RE: Oconee Unit 1  
Docket No. 50-269

JUSTIFICATION FOR FULL POWER OPERATION  
IN AN UNRODDED MODE

PROPOSED TECHNICAL SPECIFICATION  
CHANGES

FIGURE 2

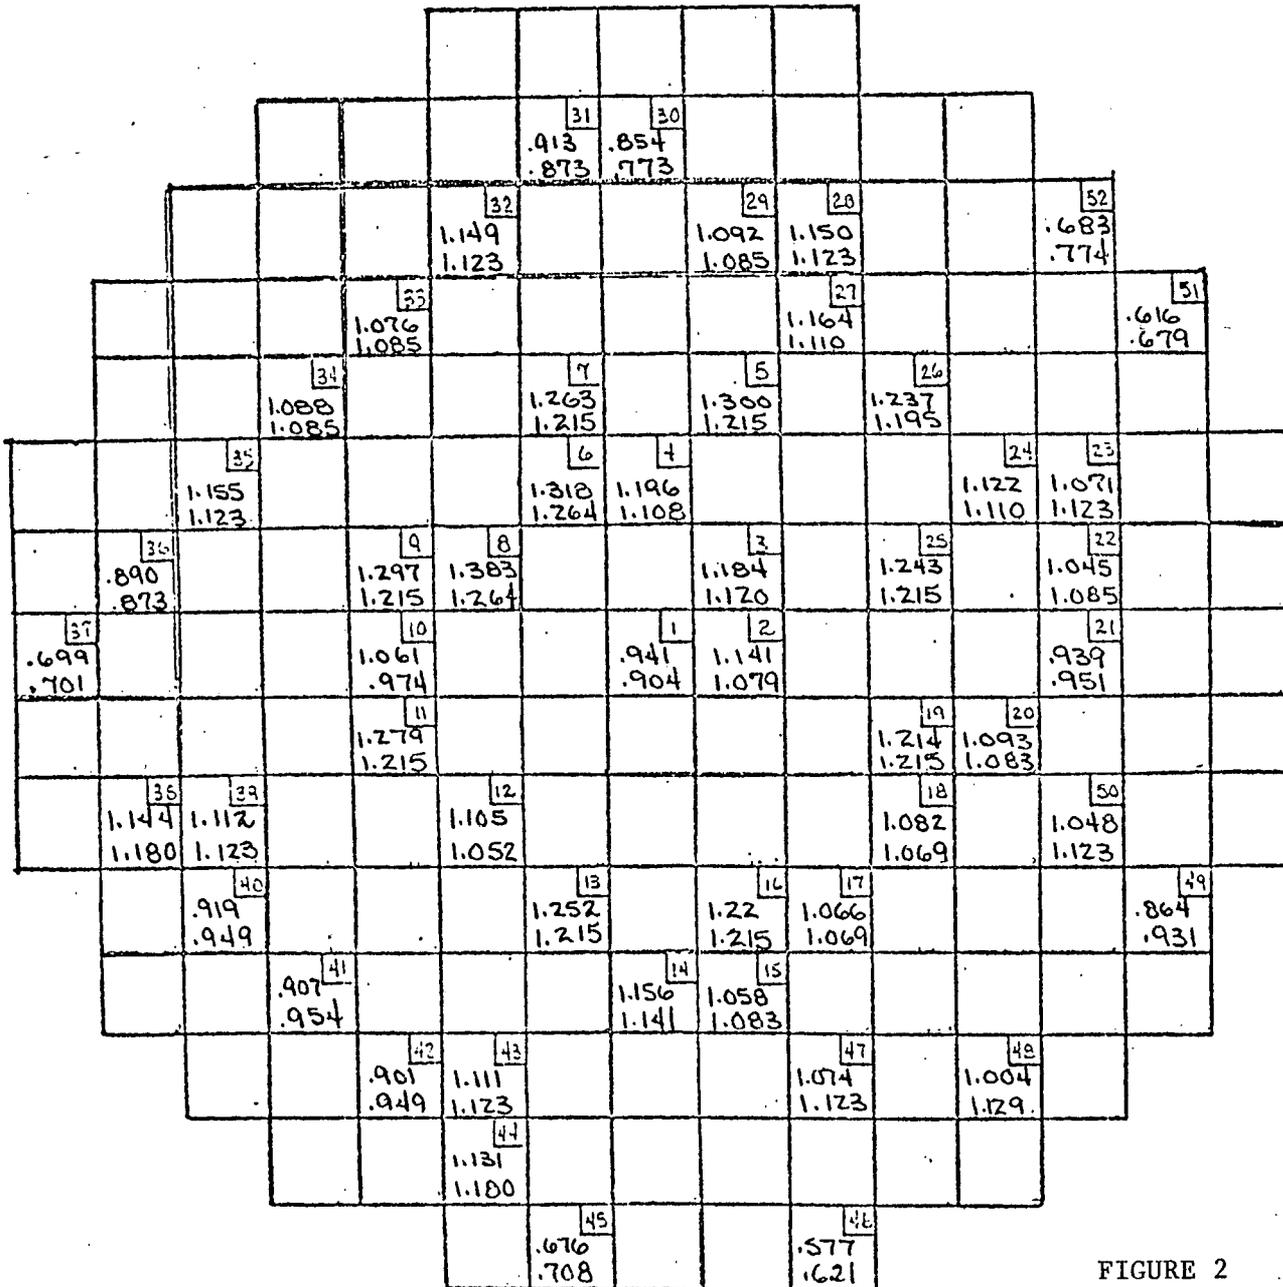
- a) this represents the relationship between peaking and tilt established by many full-core PDQ calculations with induced tilts, and
- b) the comparison of calculated and measured power distribution shown in Figures 1 and 2 at 40 and 75% of full power show that a factor of 1.09, in conjunction with the standard total and radial nuclear uncertainty factors would be conservative.

MAXIMUM RADIAL PEAK	MAXIMUM TOTAL PEAK
MEASURED 1.383 AT G6	MEASURED 1.672 AT G6 LEVEL 3
CALCULATED 1.264 AT G6	CALCULATED 1.497 AT G6 LEVEL 4&5
% DIFFERENCE	
8.604	10.467

Figure 3.5.2-1A1

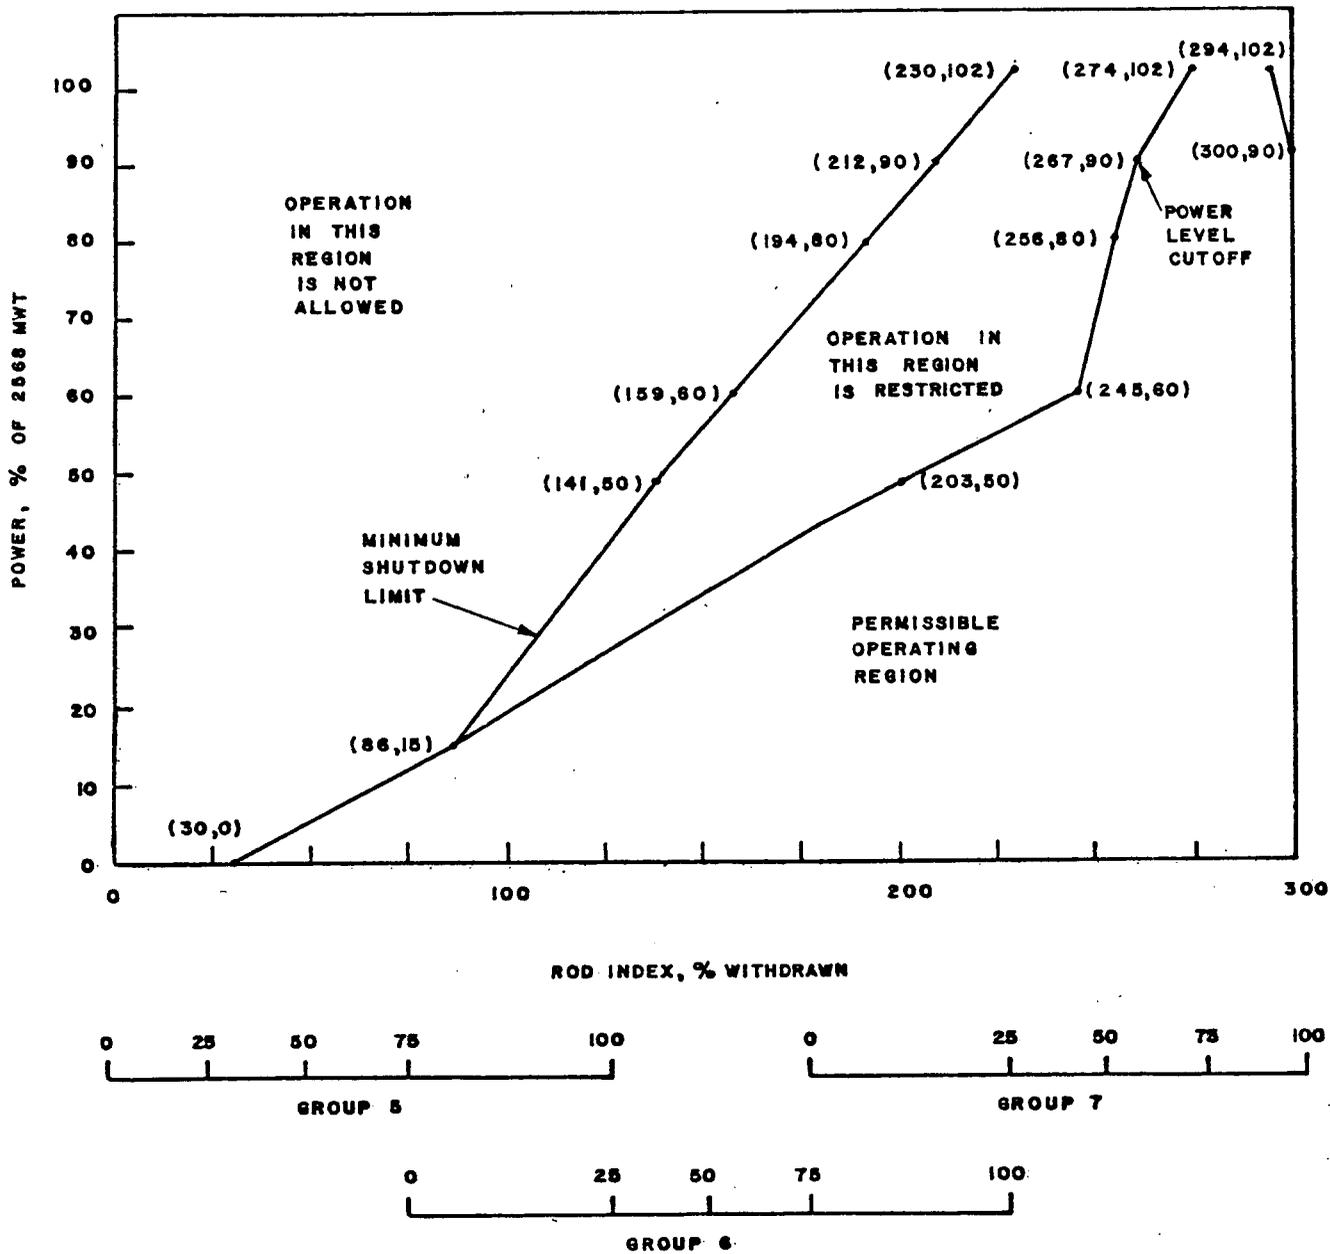
The shutdown rod insertion limits were determined using standard techniques based on symmetric conditions and adjusting these calculations to account for the tilt. The calculated stuck rod worths are increased over 50%. The measured values of banks, 5, 6 and 7 at HZP were also used to determine the shutdown margin rod insertion limits. As an added conservatism the BOC calculated total rod worth was used at 100 EFPD to determine the limits at this time. The result of this procedure is the conservative shutdown rod insertion limits shown in Figures 3.5.2-1A1 and 3.5.2-2A1.

- c. Position limits are specified for regulating and axial power shaping control rods. Except for physics tests or exercising control rods, the regulating control rod insertion/withdrawal limits are specified on figures 3.5.2-1A1,  
(Unit 1); 3.5.2-1B1, 3.5.2-1B2 and 3.5.2-1B3 (Unit 2);

d. Except for physics tests, power shall not be increased above the power level cutoff as shown on Figures 3.5.2-1A1, (Unit 1), 3.5.2-1B1, 3.5.2-1B2, and 3.5.2-1B3 (Unit 2), and 3.5.2-1C1, 3.5.2-1C2, 3.5.2-1C3 (Unit 3), unless the following requirements are met.

OCONEE 1 CYCLE 4 ROD POSITION  
LIMITS FOR FOUR PUMP OPERATION  
FROM 0 TO 100 (+10) EFPD

Figure 3.5.2-2A1

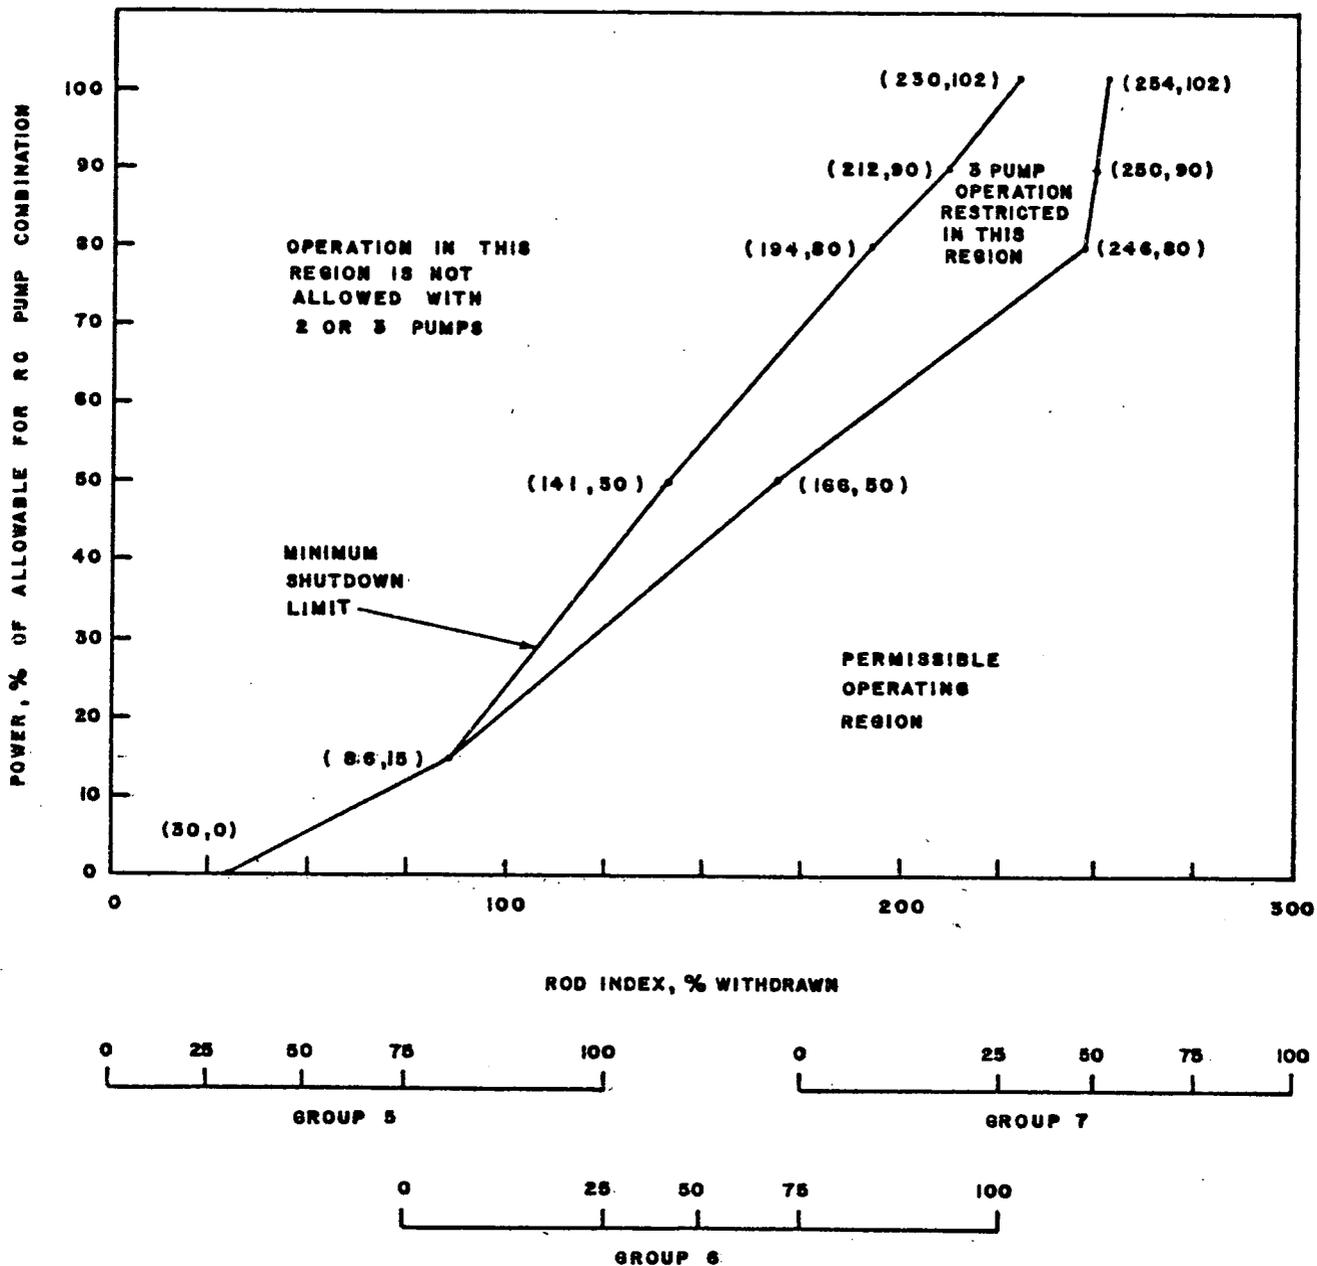
3.5.2-1C1, 3.5.2-1C2 and 3.5.2-1C3 (Unit 3) for four pump operation, and on figures 3.5.2-2A1,  
(Unit 1); 3.5.2-2B1, 3.5.2-2B2 and 3.5.2-2B3 (Unit 2);

OCONEE 1 CYCLE 4 ROD POSITION LIMITS FOR TWO AND THREE PUMP OPERATION FROM 0 TO 100 ( $\pm 10$ ) EFPD  
 OCONEE NUCLEAR STATION
